Access Compliance Report

Public Rights-of-Way

(Curb Ramps)

Intersection ID: 7031	Main Street: BROOKSHIRE_BV	Cross Street: OAKDALE_RD	Location: NE
ADA ID: 3C5F309B55F1	Ramp Type: Perp	Initial Pass/Fail: Fail	Overall Compliance: No
Severity Score: 22.5			
Codes/Mitigation Info/Possible Solution		Field Measurements/Component Compliance

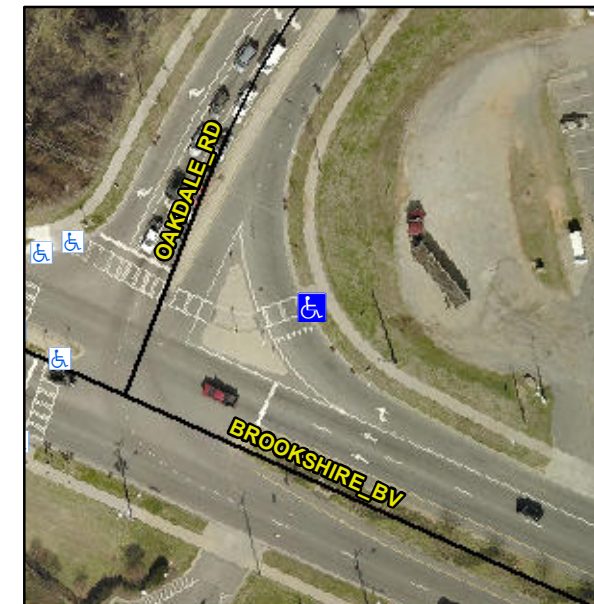
Not Found, R304.5.1, R304.2.2, R304.5.3

Compliance	Description	Data	Compliance	Description	Data
N/A	Ramp Length (in)	95.0	No	Ramp Slope (%)	8.6
No	Ramp Width (in)	45.5	No	Ramp XSlope (%)	2.6
N/A	Flare Type LT	N/A	N/A	Flare Type RT	N/A
N/A	Flare Slope LT (%)	N/A	N/A	Flare Slope RT (%)	N/A
N/A	Flare Traversable LT?	N/A	N/A	Flare Traversable RT?	N/A
N/A	Landing Length (in)	N/A	N/A	DWS Provided?	N/A
N/A	Landing Width (in)	N/A	N/A	DWS Contrast?	N/A
N/A	Landing Slope (%)	N/A	N/A	DWS Length (in)	N/A
N/A	Landing X Slope (%)	N/A	N/A	DWS Full Width?	N/A
N/A	Landing Curb? (Y/N)	N/A	N/A	DWS Offset (in)	N/A
N/A	Shared Landing?	N/A			
N/A	Gutter Ponding?	N/A	N/A	Gutter Slope (%)	N/A
N/A	Gutter Lip Ht (in)	N/A	N/A	Gutter X Slope (%)	N/A
N/A	Painted X Walk1?	Yes	N/A	Painted X Walk2?	N/A
	X Walk 1 Direction	To SW		X Walk 2 Direction	N/A
N/A	X Walk 1 Width (in)	112.0	N/A	X Walk 2 Width (in)	N/A
	X Walk 1 Slope (%)	1.9		X Walk 2 Slope (%)	N/A
	X Walk 1 X Slope (%)	1.6		X Walk 2 X Slope (%)	N/A

Remove & Replace Entire Ramp.
